Access Compliance Report

Public Rights-of-Way

(Curb Ramps)

Intersection ID: 10867	Main Street: E_35TH_ST	Cross Street: THE_PLAZA	Location: W
ADA ID: F14EA956A079	Ramp Type: PerpDiag	Initial Pass/Fail: Fail	Overall Compliance: No
Severity Score: 22.5			
Codes/Mitigation Info/Possible Solution		Field Measurements/Component Compliance

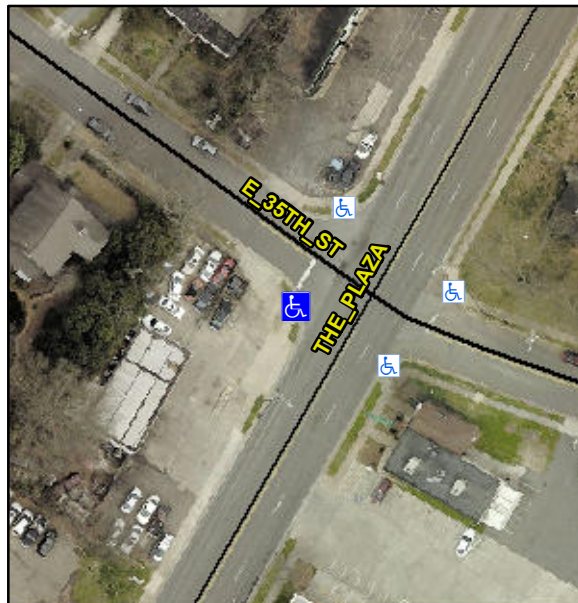
Not Found, R304.5.1, R304.2.2, R304.5.3

Compliance	Description	Data	Compliance	Description	Data
N/A	Ramp Length (in)	49.0	No	Ramp Slope (%)	9.6
No	Ramp Width (in)	42.0	No	Ramp XSlope (%)	2.8
N/A	Flare Type LT	N/A	N/A	Flare Type RT	N/A
N/A	Flare Slope LT (%)	N/A	N/A	Flare Slope RT (%)	N/A
N/A	Flare Traversable LT?	N/A	N/A	Flare Traversable RT?	N/A
N/A	Landing Length (in)	N/A	N/A	DWS Provided?	N/A
N/A	Landing Width (in)	N/A	N/A	DWS Contrast?	N/A
N/A	Landing Slope (%)	N/A	N/A	DWS Length (in)	N/A
N/A	Landing X Slope (%)	N/A	N/A	DWS Full Width?	N/A
N/A	Landing Curb? (Y/N)	N/A	N/A	DWS Offset (in)	N/A
N/A	Shared Landing?	N/A			
N/A	Gutter Ponding?	N/A	N/A	Gutter Slope (%)	N/A
N/A	Gutter Lip Ht (in)	N/A	N/A	Gutter X Slope (%)	N/A
N/A	Painted X Walk1?	No	N/A	Painted X Walk2?	No
	X Walk 1 Direction	To SE		X Walk 2 Direction	To NE
N/A	X Walk 1 Width (in)	N/A	N/A	X Walk 2 Width (in)	N/A
	X Walk 1 Slope (%)	1.2		X Walk 2 Slope (%)	1.3
	X Walk 1 X Slope (%)	2.2		X Walk 2 X Slope (%)	2.5

Remove & Replace Curb Ramp With Two New Directional Ramps or Equivalent.
